HISTORIC DISTRICT REVIEW BOARD MEETING AGENDA

Title: HDRB #23-002; Porch roof replacement and repairs; 722 Park Ave

Summary Information			
Applicant Request	Porch roof replacement and porch repairs		
Address	722 Park Avenue, Herndon, Virginia		
Fairfax County Tax Map Number	0104 03030003A		
Owners	Richard V Slepetz and Linda H Slepetz		
Applicant	Linda H Slepetz		
Business/Organization	Private residence		
Property Use	Residence		
Zoning District	R-15, Residential Single Family-15 District		
HDO Designation	Contributing		
Adjacent Zoning	North: R-15, Residential Single-Family – 15 District South: R-10, Residential Single-Family – 10 District (use, place of worship) East: R-15, Residential Single-Family – 15 District West: R-15, Residential Single-Family – 15 District		
Building Type(s)	Two story residential	Date of Construction:	c.1912
Architectural Style(s)	Victorian		
Exterior Material(s)	Wood lap and shingle siding, metal roofing		
Neighborhood Design Profile	Single family residential		
Comprehensive Plan Land Use Designation	Neighborhood Conservation

Date
12-18-22
New porch roof

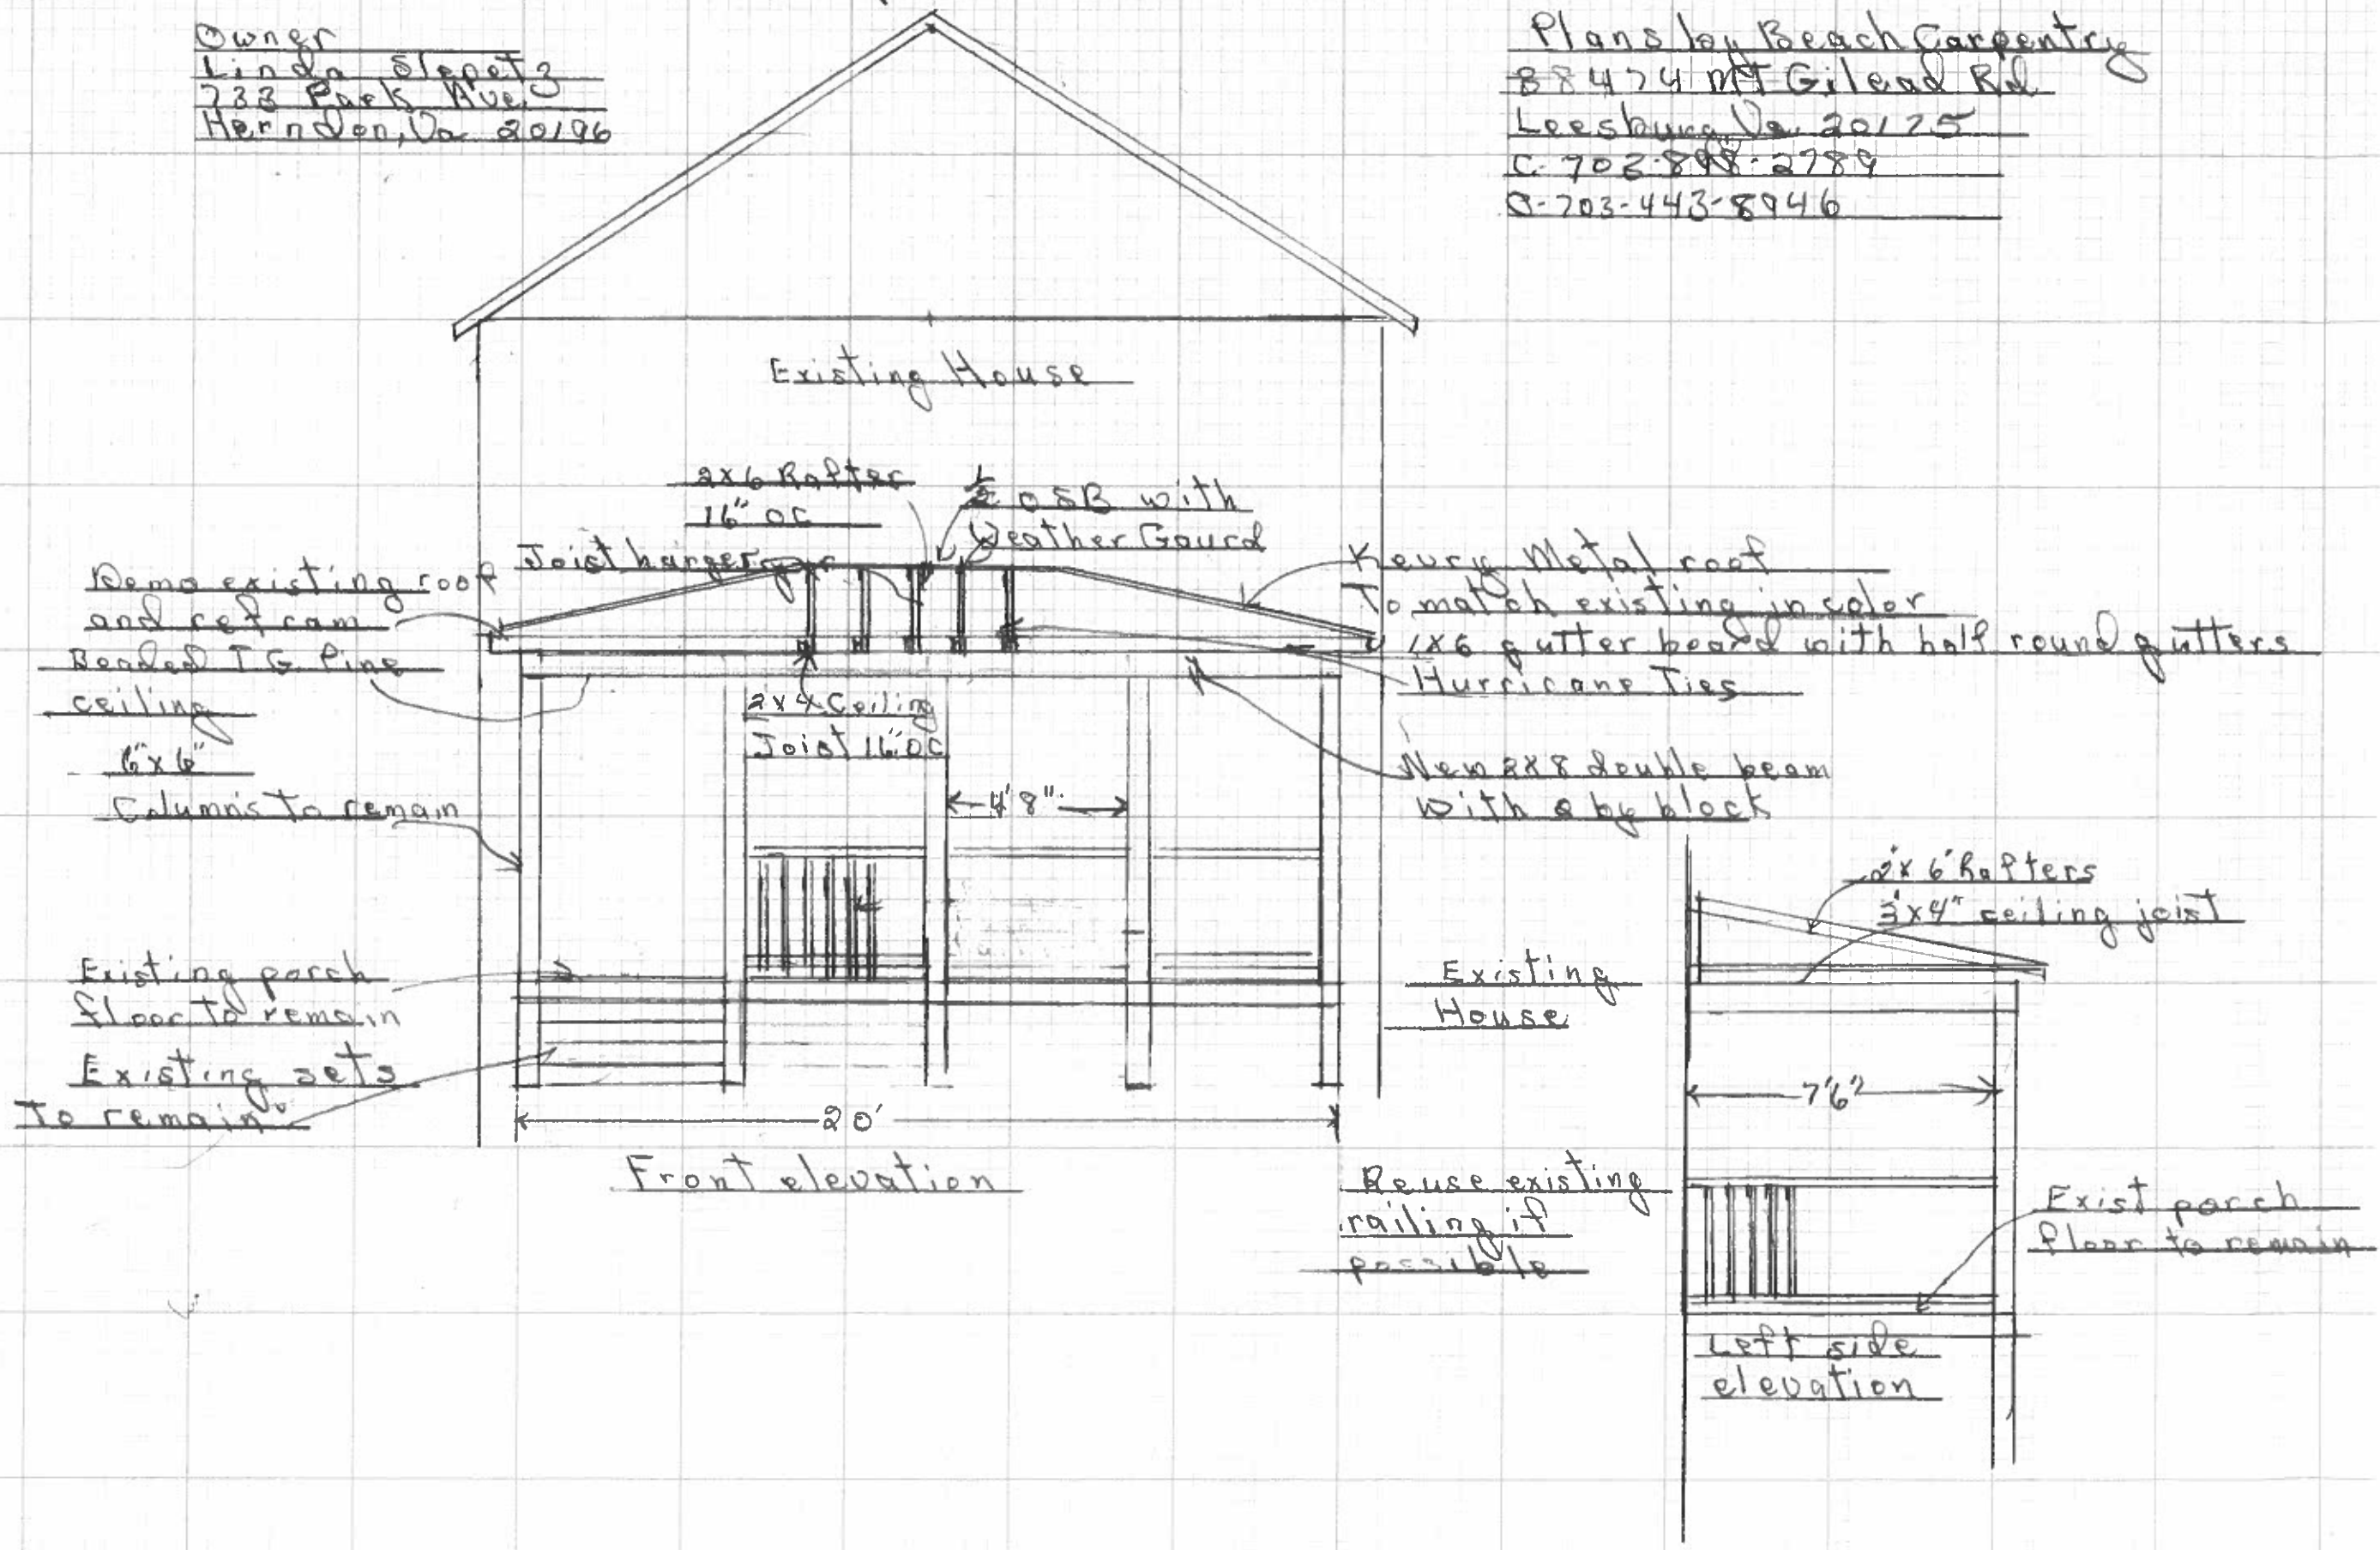
Porch roofing. The application states that the replacement roofing material is standing seam metal to match the existing. Staff is asking for additional information regarding the panel width of the exiting standing seam roof and panel width of the proposed replacement roofing. Portions of the roofing structure are to be replaced due to deterioration resulting from water infiltration.

allows for the remainder of the porch fascia, soffits and eaves to be unobstructed by external gutters and downspouts. The submitted plans do not detail the type of gutter or downspout system proposed beyond that the gutters are to be half-round. Staff is requesting more information regarding this including materials samples and/or materials specifications, and renderings or descriptions of how the proposed system will interact with the existing roof and porch elements.

- Information regarding existing and proposed standing seam metal panels.
 - Materials specifications for proposed water egress system: gutter, downspout etc.

- Details regarding how the proposed gutter and downspout will interact with the existing porch and new porch roof.
 - Type of wood to be used for repair and replacement of exterior wood elements.
